Technical Service Bulletin: TSB190042	Released Date: 08-Apr-2019
New Vented Coolant Drain Line Kit to Reduce Variable Geometry Turbocharger Actuator Overheating: FC2636 and FC1894

Product Affected

- ISL9 CM2350 L101
- L9 CM2350 L123B

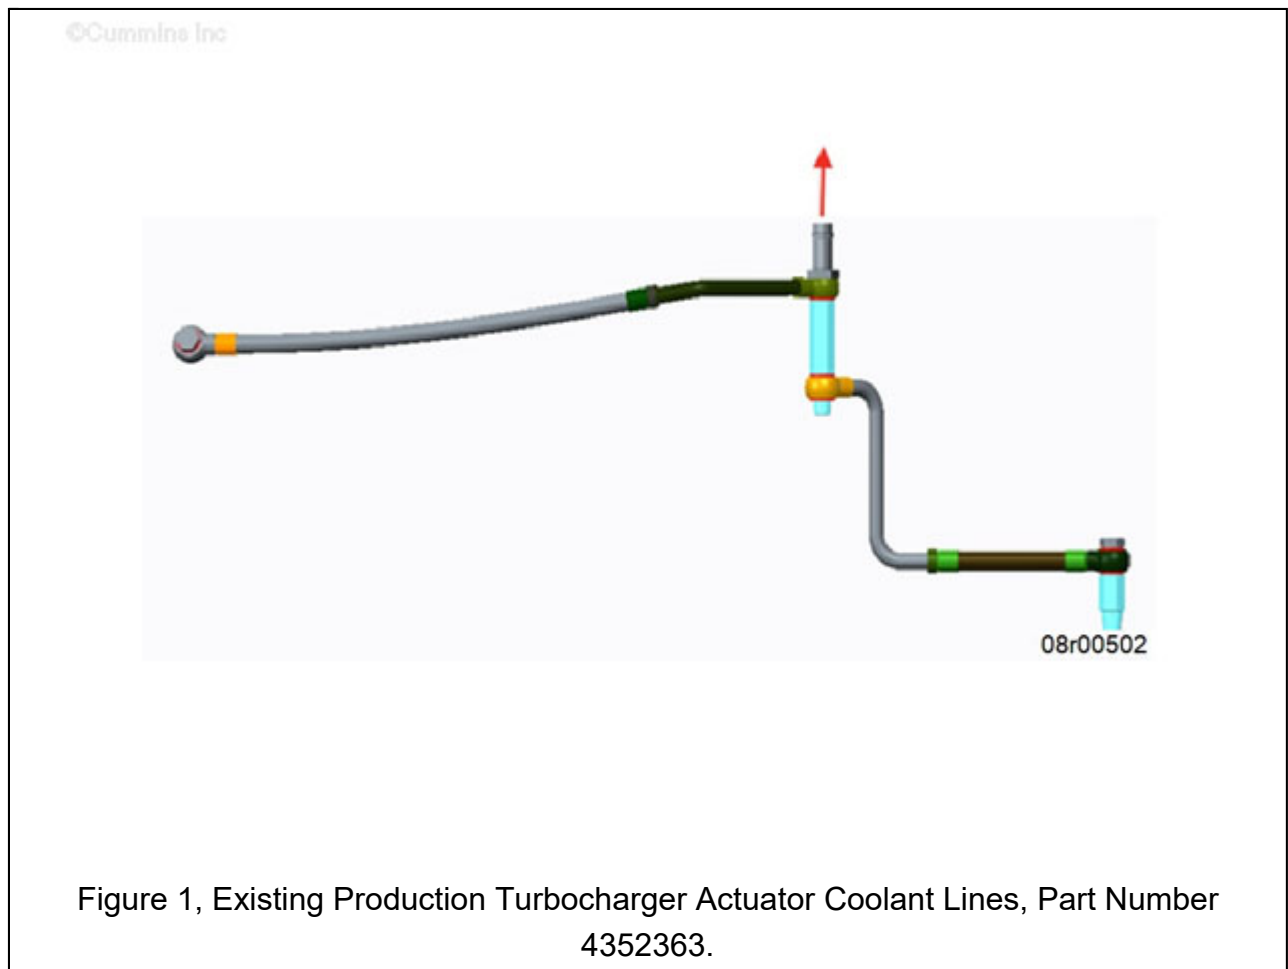
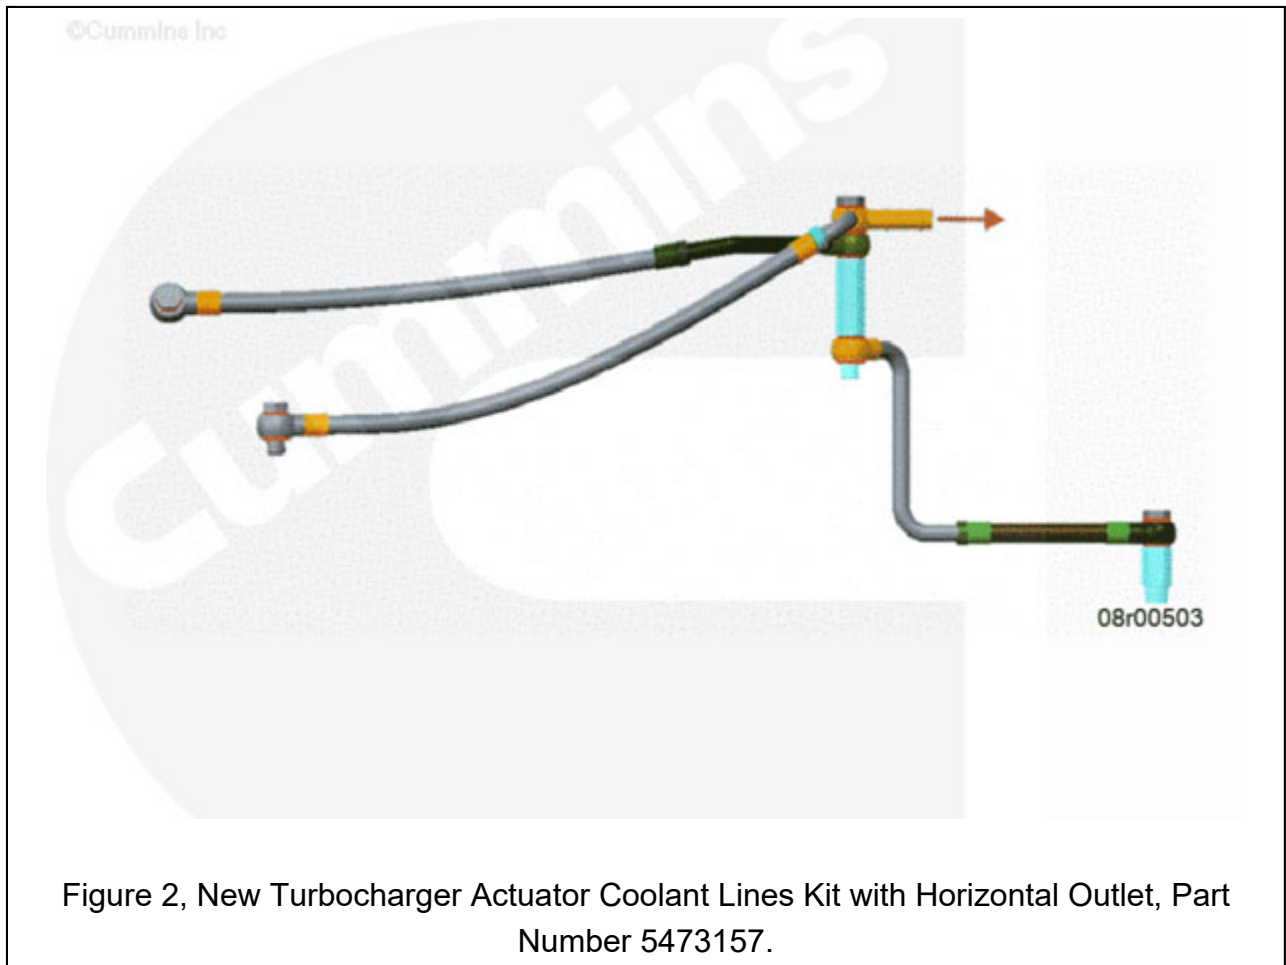
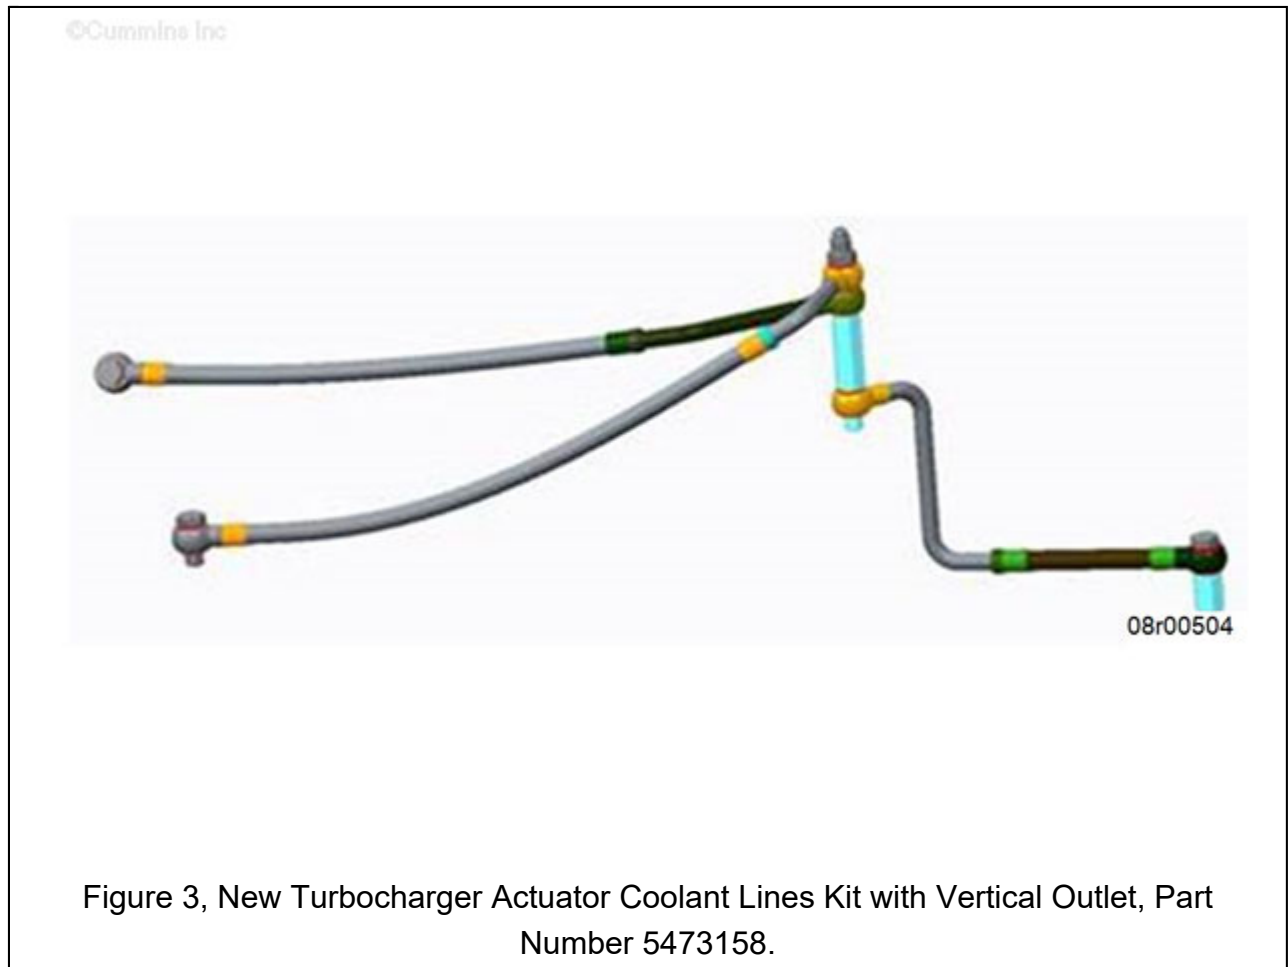
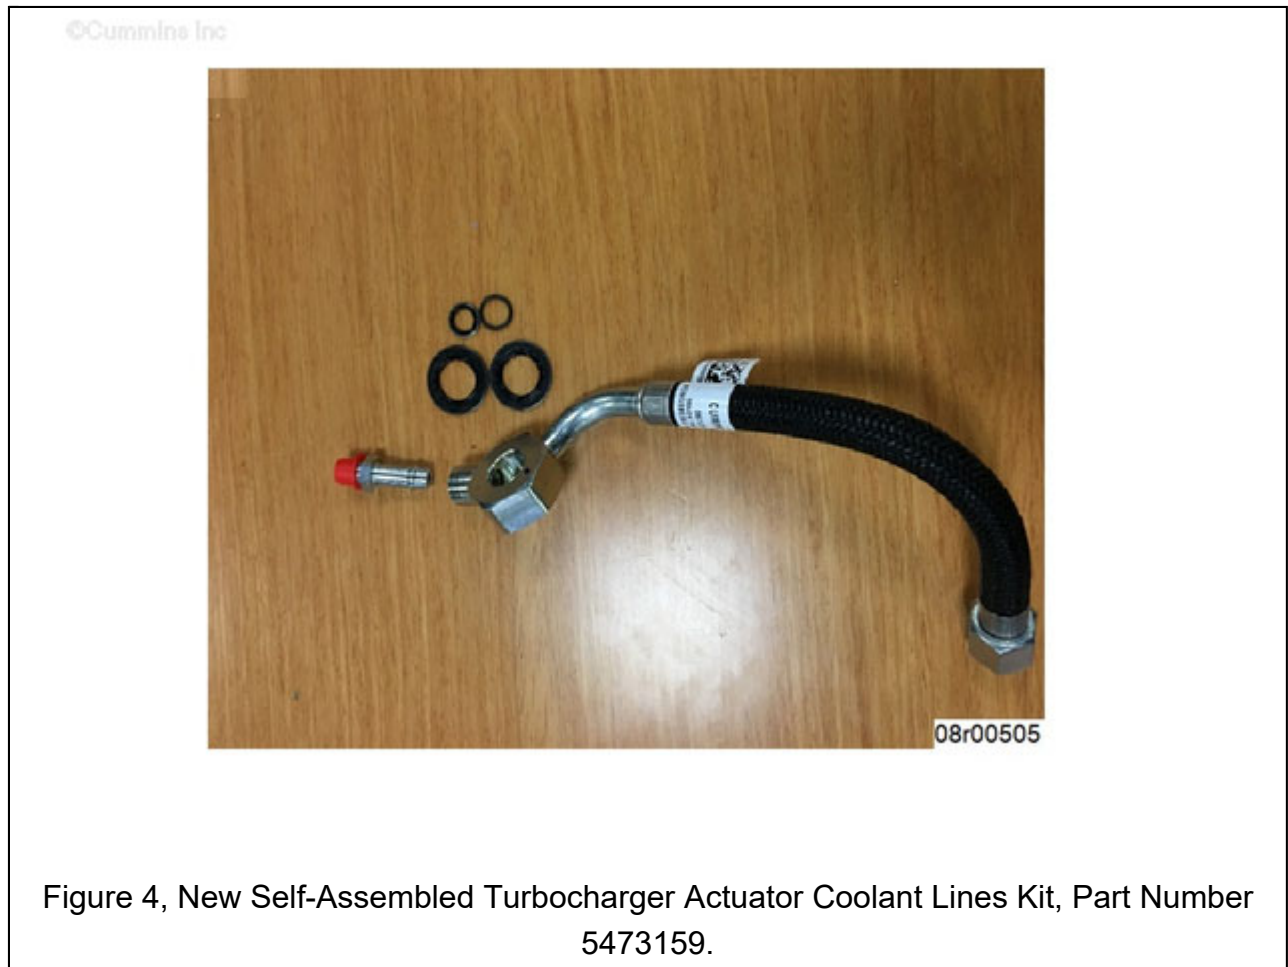
- New turbocharger actuator vented coolant drain line kits are available with a horizontal or vertical outlet.
- Turbocharger actuator vented coolant drain line orientation **must** be determined in order to determine correct service kit to be ordered. See Figures 1, 2, 3, and 4 for existing product and service kit layouts.
- See Figure 5 for new production routing.
- See Table 1 for kit part numbers.
- For new turbocharger actuator coolant drain line kit installation, see corresponding Service Manual. Reference Procedure 008-017 in Section 08.

Replace turbocharger actuator vented coolant drain line with corresponding kit.
